Module Title PPS PA 83-18 Pinellas County Phase II

Re: Application for Power Plant Siting Certification (PPSC), Phase II

PROPOSAL FOR COMPLIANCE WITH FLORIDA
ADMINISTRATIVE CODE AT THE PINELLAS
REFUSE TO ENERGY FACILITY

The Department of Environmental Regulation has reviewed the draft supplemental power plant site certification application presented on March 30, 1983. The following comments come from the staff who reviewed the draft documents:

PLAN

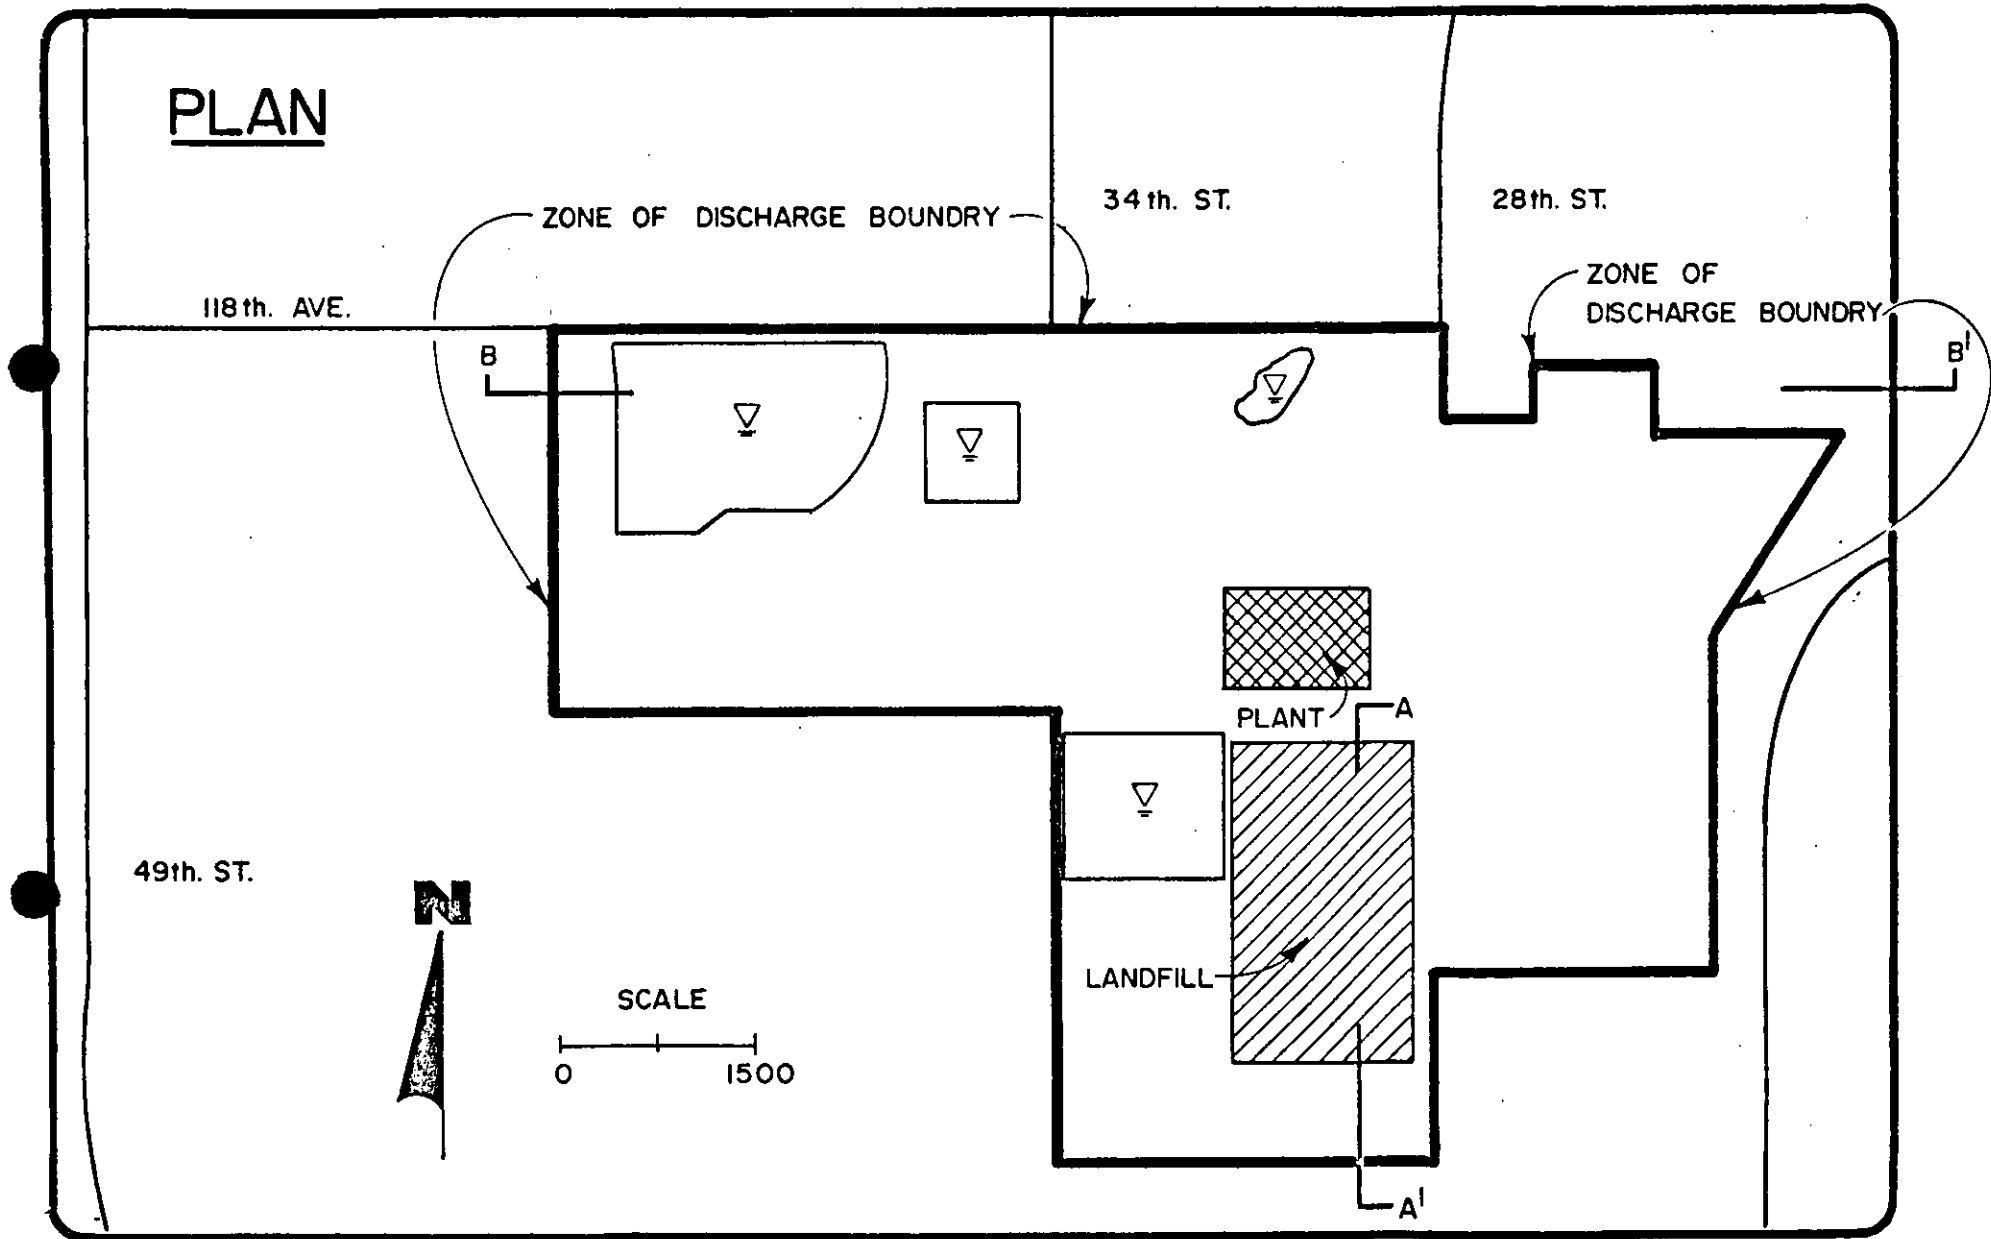
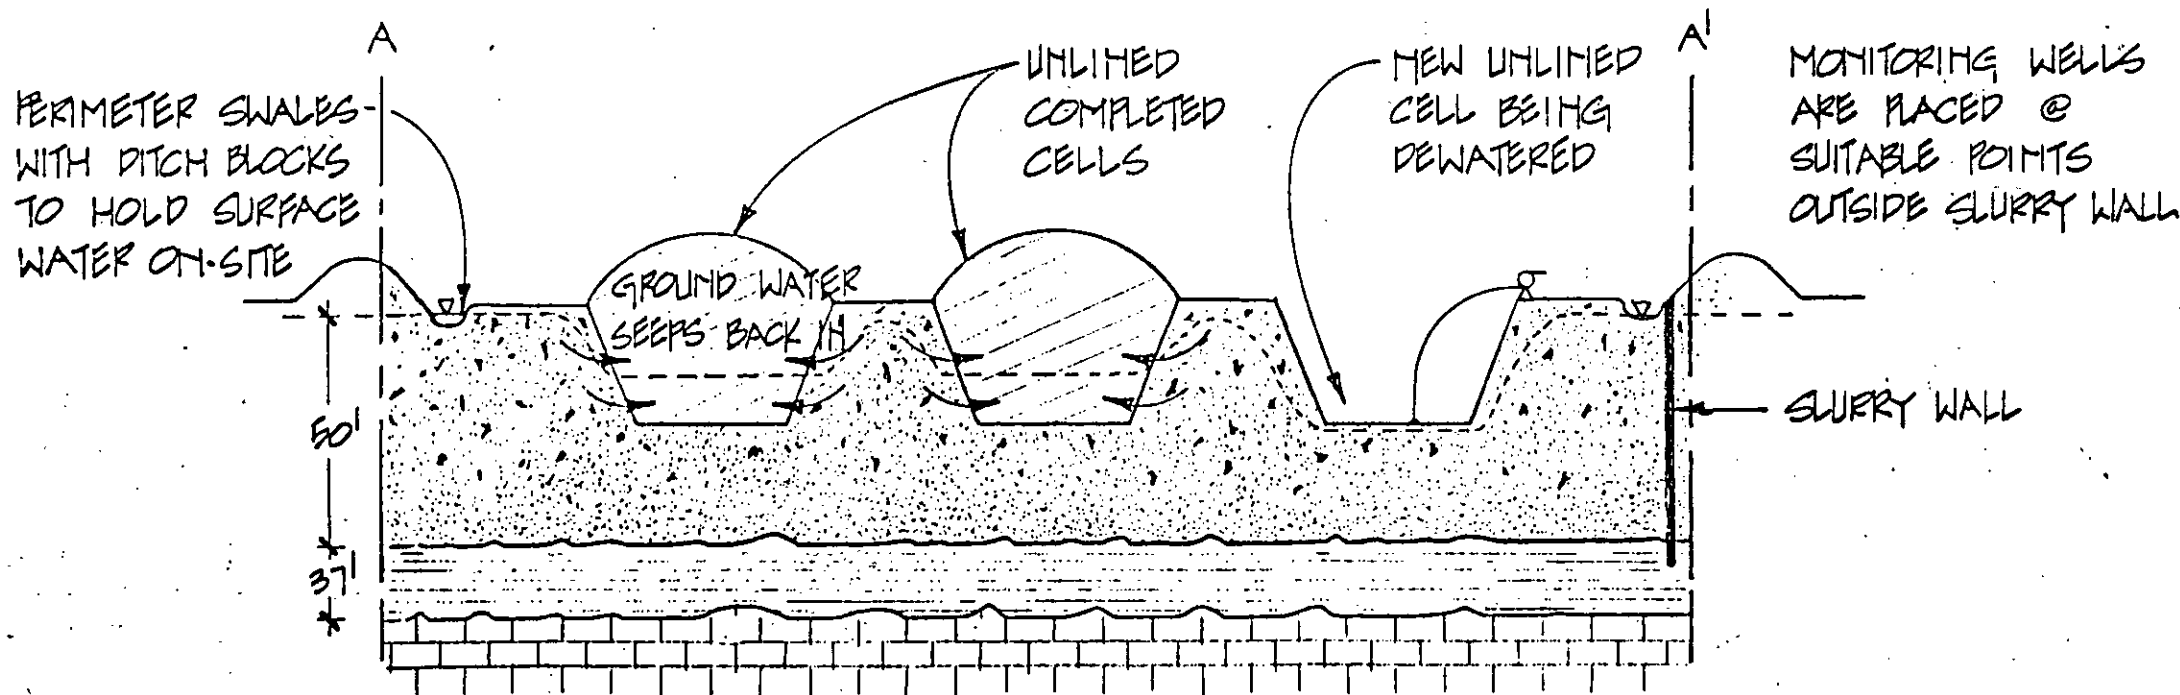
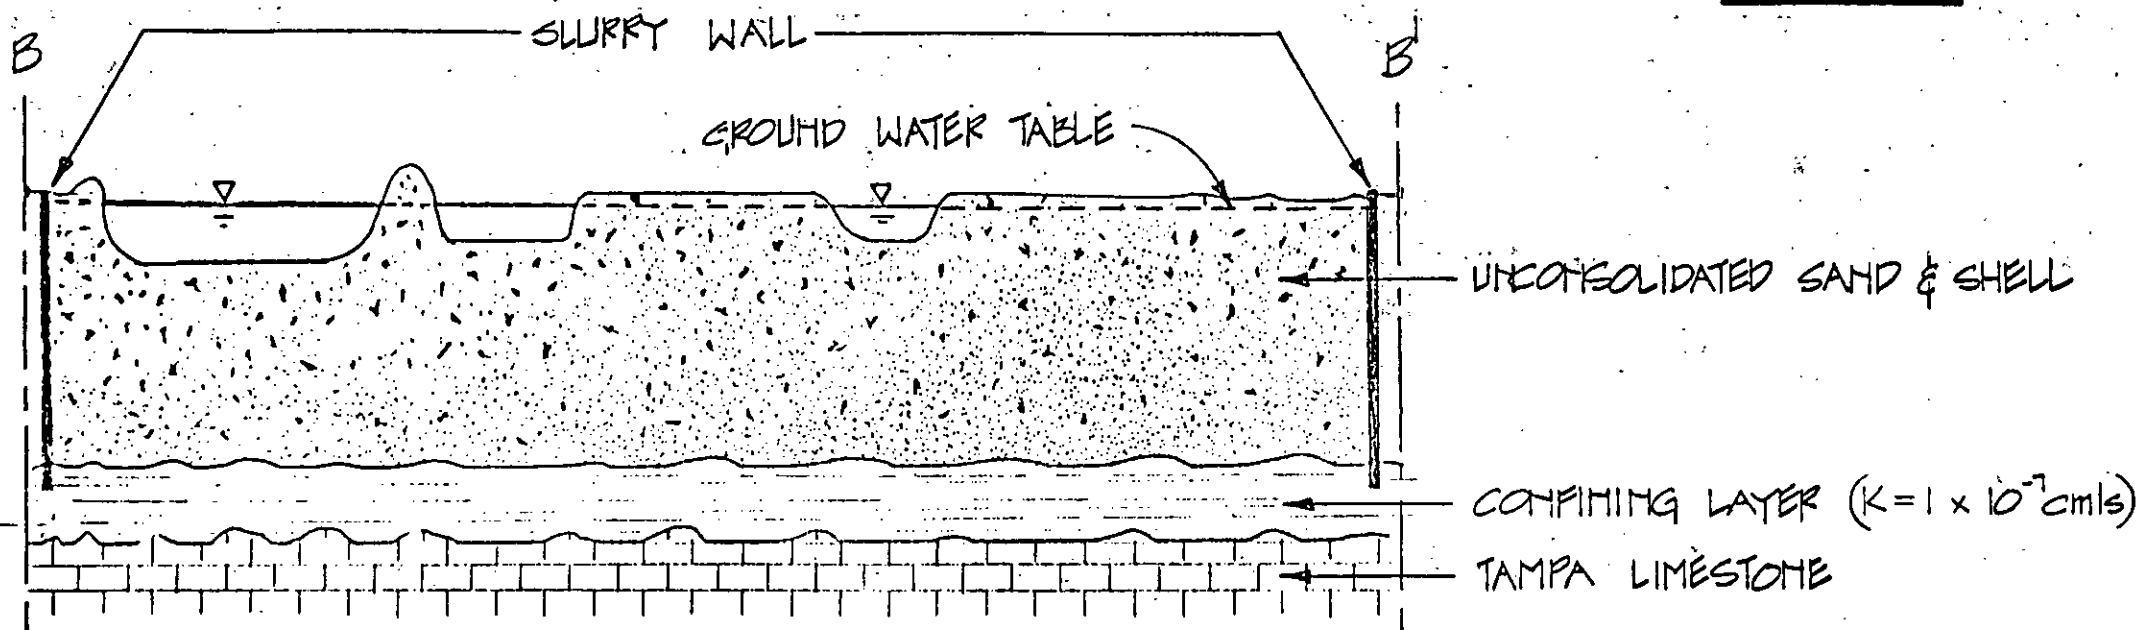
Attached are conceptual drawings for a system of ground water containment at the Pinellas Refuse to Energy Facility. As shown, it is proposed that all land within the 730 acre site be surrounded by a bentonite soil slurry wall keyed into an underlying clay layer of low permeability. Prior to wall construction a detailed hydrogeologic survey will be conducted to examine the real extent of the confining layer. The absence of undesirable features such as artesian flow and limestone outcrops will be verified. This evaluation will rely heavily on soil borings taken at centers of a 300' x 300' grid cell matrix over the entire site. The terminal depth of each boring will be the top of the calcareous Tampa limestone which lies at an average depth of 54 feet below land surface. Boring tests will include Atterburg limits, standard penetration tests, and sieve analysis. When the confining layer is encountered Shelby tube samples will be taken at not less than 3 foot intervals through a minimum 10 foot thickness through the layer. The samples will be tested for permeability.

If the continuity and permeability of the underlying confining layer is suitable for vertical flow attenuation, the slurry wall will be constructed. With an in-place bentonite concentration of 1 to 3% by weight, the wall will have a permeability in the desired range of 1×10^{-7} cm/s (1.2f/yr.). .10 The wall will be 3 ft. thick and will be keyed into the confining layer a minimum of 3 ft.; this layer underlies the site at a nominal depth of 29 ft. below land surface. Since ground water coming into contact with the slurry wall may have a high dissolved mineral content some ionic substitution on the bentonite crystal lattice may occur resulting in a slight increase in permeability. Therefore, prior to wall placement, appropriate tests will be conducted to identify the magnitude of permeability change; derived data will aid in adjusting the clay-to-soil mix ratio so that the desired 10^{-7} permeability is attained.

During wall construction borings will be taken on 500 foot centers along the slurry wall right-of-way. The same boring tests described above will be repeated here. This will ensure that the wall is being keyed into proper strata and that no untoward geologic conditions are present.

Once the wall is in place the water level within will rise. This will result in an undesirable increase in outward flow through the wall. The ideal situation will be to maintain equal water table elevations on either side of the wall. Under this condition there will be virtually no flow. A comprehensive water management plan is now being devised to accomplish this goal. A major effort in this design is the application of EPA's HSP-F (Hydrologic Simulation Program-Fortran) model.

With the site completely surrounded by the slurry wall, and the desired water levels maintained, leachate from solid waste cells would be contained. New cells would be constructed below grade. Before placing solid waste within, the excavated pit is dewatered and the removed water treated in an

In accordance with the ground water revisions of January 1, 1983, it is proposed that the entire 730 acre site be designated a zone of discharge (ZOD). Specifically:
